TURKEY POINT NUCLEAR GENERATING STATION UNIT 3 AND UNIT 4

IMPROVED TECHNICAL SPECIFICATIONS CONVERSION

ITS SECTION 3.2 POWER DISTRIBUTION LIMITS

Revision 0

Figure B 3.2.1B-1 (page 1 of 1)
K(Z) - Normalized F_Q(Z) as a Function of Core Height

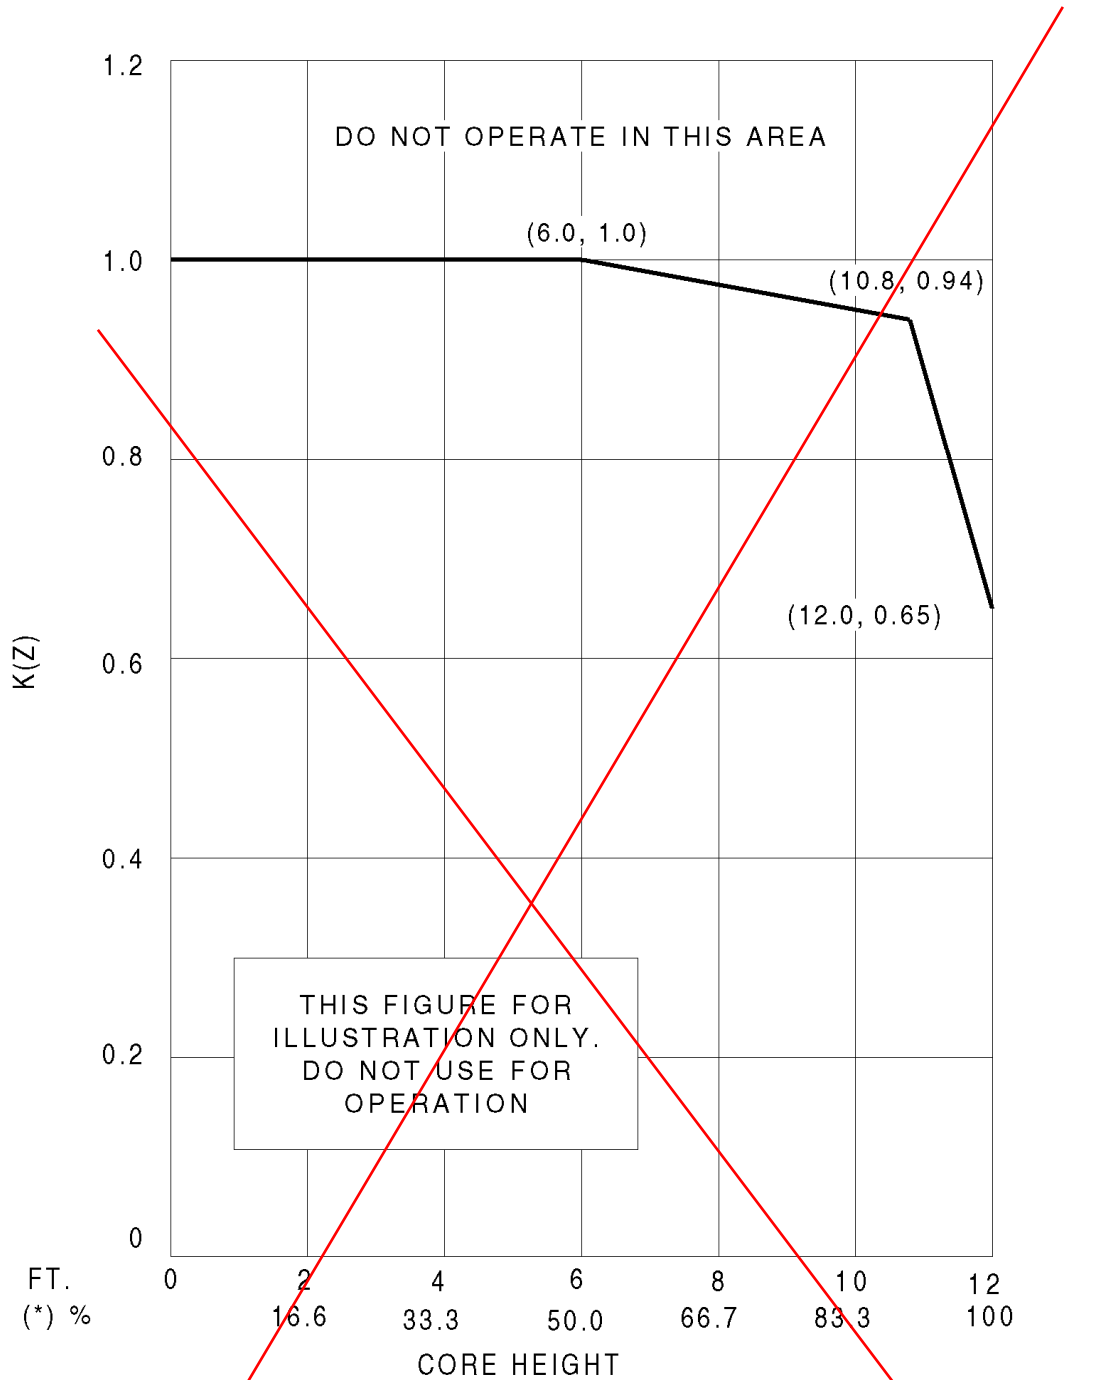
5. ITS Bases 3.2.1 contains Figure B 3.2.1 B-1, $K(Z) - \text{Normalized } F_Q(Z) \text{ as a Function of Core Height}$. The PTN CTS 3.2.1 Bases do not contain this figure. Therefore, this figure is not being retained in the PTN ITS 3.2.1 Bases.

Figure B 3.2.3B-1 (page 1 of 1)
AXIAL FLUX DIFFERENCE Acceptable Operation Limits
as a Function of RATED THERMAL POWER

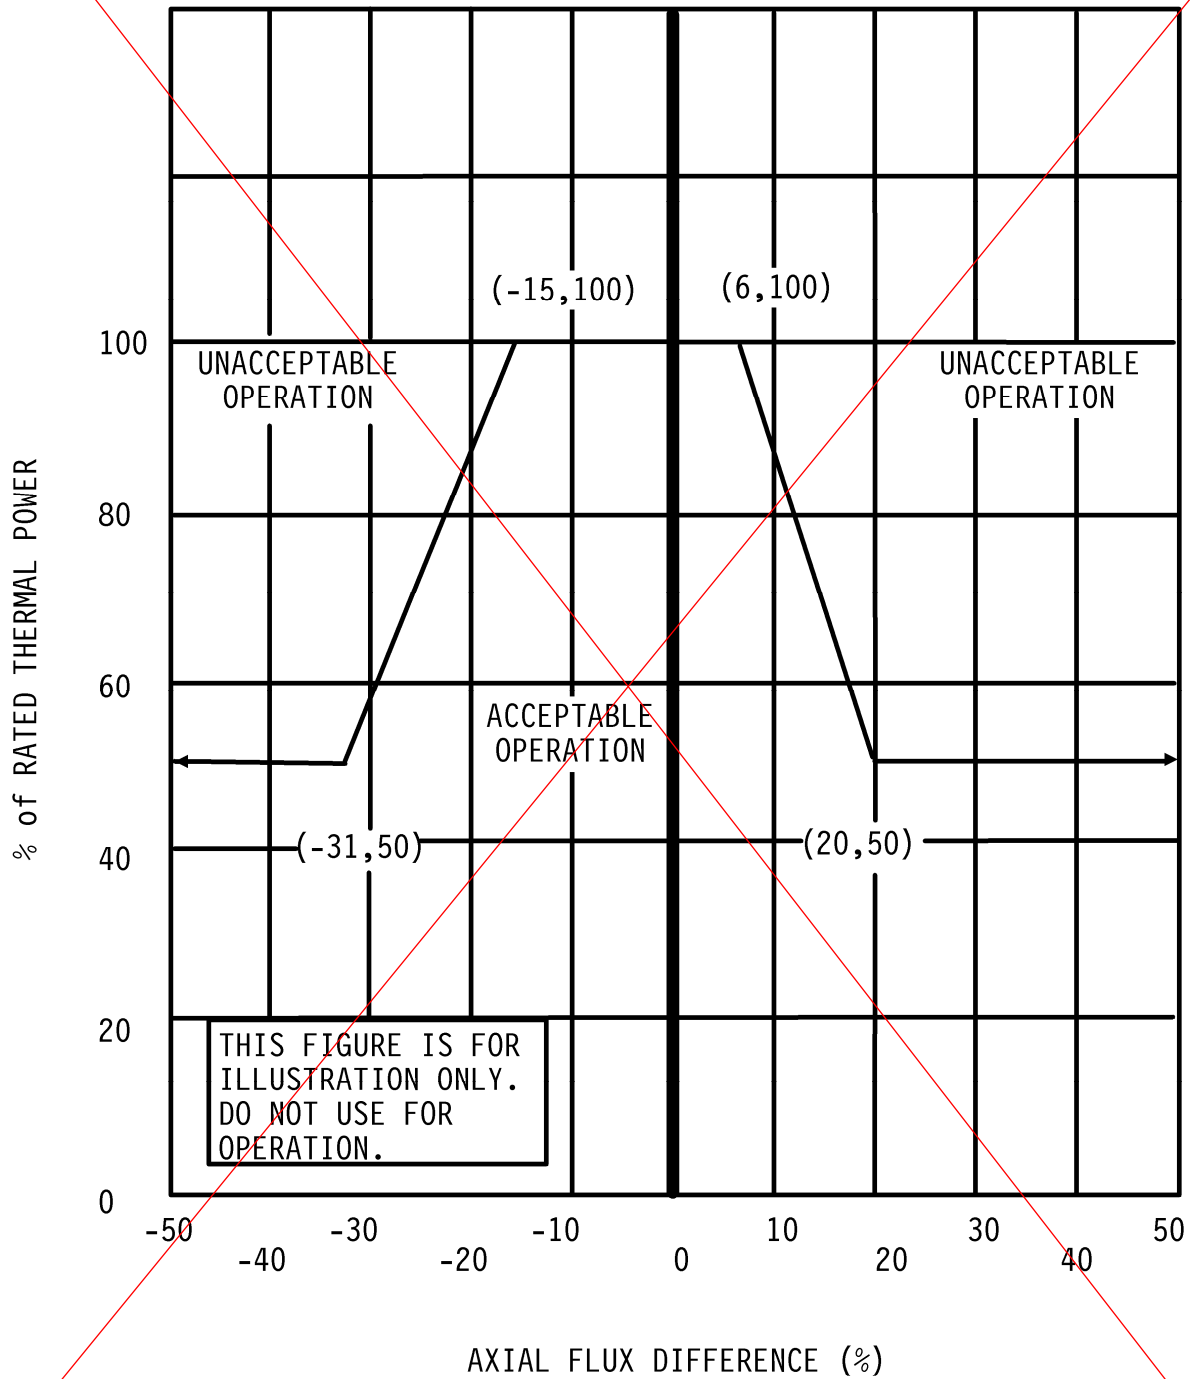
5. ISTS 3.2.3 Bases contains Figure B 3.2.3B-1. This Figure is located in the Turkey Point Nuclear Generating Station (PTN) Core Operating Limits Report (COLR). Therefore, this figure is not included in the Bases for ITS 3.2.3.
